MEMORANDUM TO TEAM LEADERS AND CONSULTANTS

SUBJECT: End Wall Details

PIPE UNDERDRAIN DETAIL

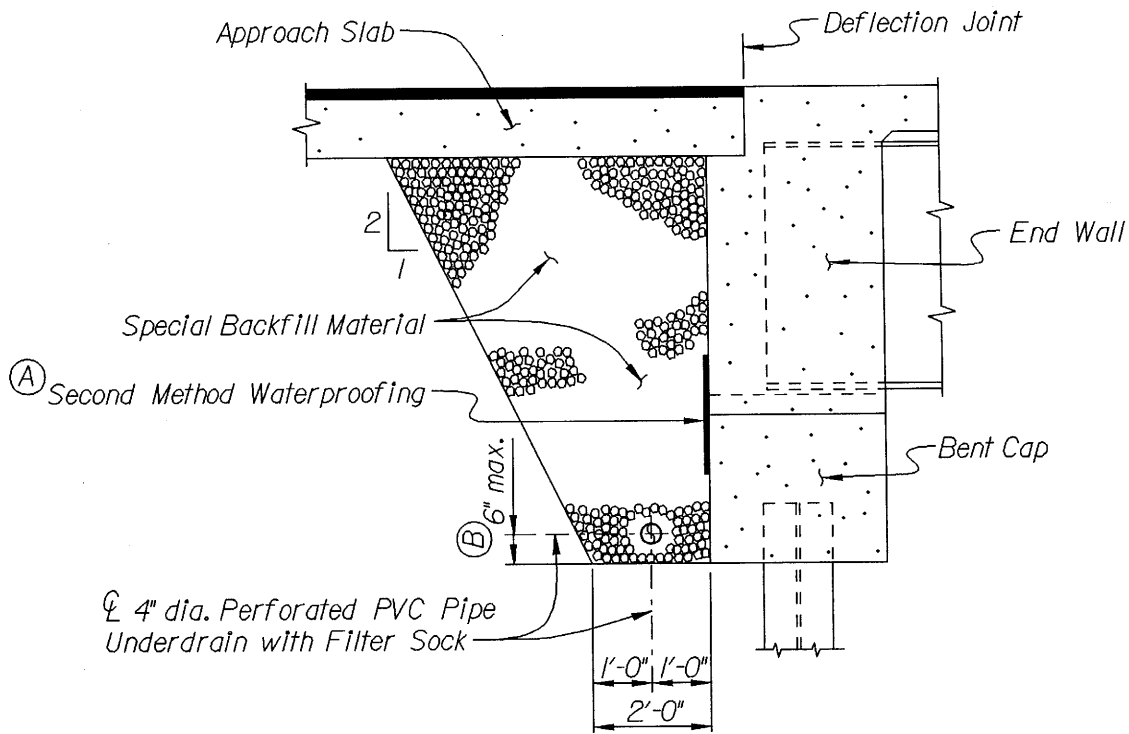
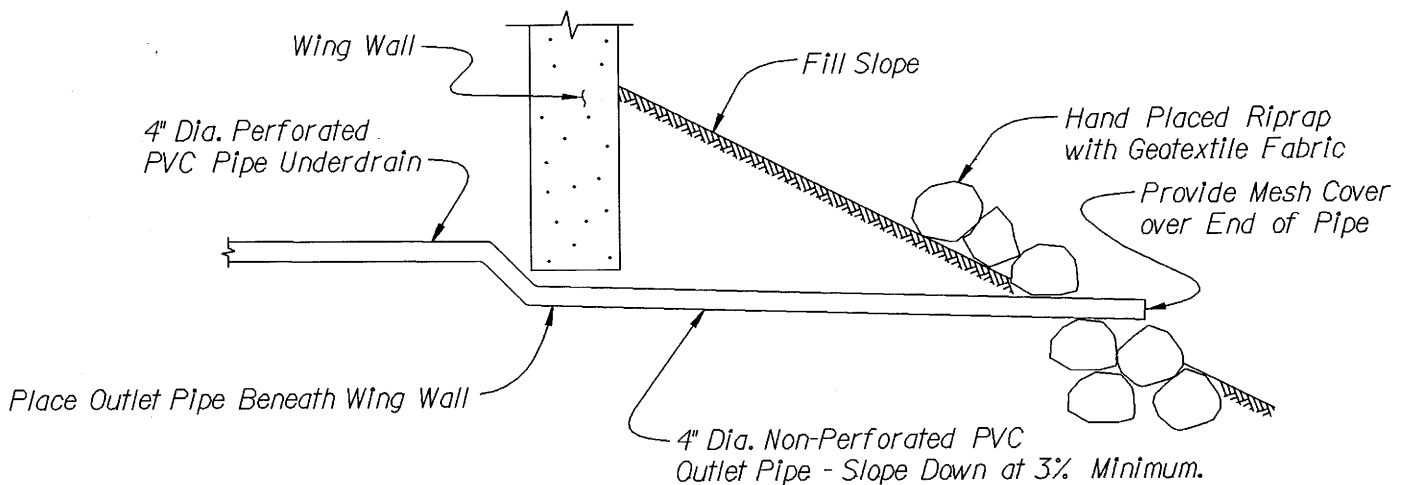
The embankment adjacent to the end walls of all prestressed and structural steel end spans shall be detailed with a special backfill material and underdrain as shown on the attached drawing. Additionally, the construction joint between the end wall and the bent cap shall be waterproofed.

For integral end bents, the end wall shall be detailed the full width of the end bent and the end wall concrete shall be cast as the last portion of the deck pour of the end span.

The requirements of this memorandum replace the requirements of DM0500 and DM0502. For previously completed plans that do not conform to the requirements of this memorandum, the State Bridge Design Engineer will, on a case-by-case basis, assess the need for revisions.

4" Dia. Perforated PVC Pipe Underdrain shall comply with Section 802.07 of the Standard Specifications. Special Backfill Material shall be #789 Coarse Aggregate, Uncompacted, and shall comply with Section 802.08 of the Standard Specifications. Filter Sock shall be Geotextile for Drainage Filtration, Class I Fabric (Protected) - See Special Provisions. All costs of furnishing and installing the 4" Dia. Perforated PVC Pipe Underdrain, Filter Sock, Special Backfill Material, 4" Dia. Non-Perforated PVC Outlet Pipe, Riprap, and Geotextile Fabric for Riprap shall be included in the unit price bid for 4" Perforated Pipe Underdrain. Measurement of the 4" Perforated Pipe Underdrain shall be taken along the back face of the End Wall from inside edge of Wing Wall to inside edge of Wing Wall and all costs associated with the construction of the Outlets shall be considered incidental and Included in the unit price bid for the 4" Perforated Pipe Underdrain.

(A) Second Method Waterproofing shall extend the full length of the End Wall. See Section 814 of the Standard Specifications.

(B) Slope Pipe a minimum of 0.5% to drain.
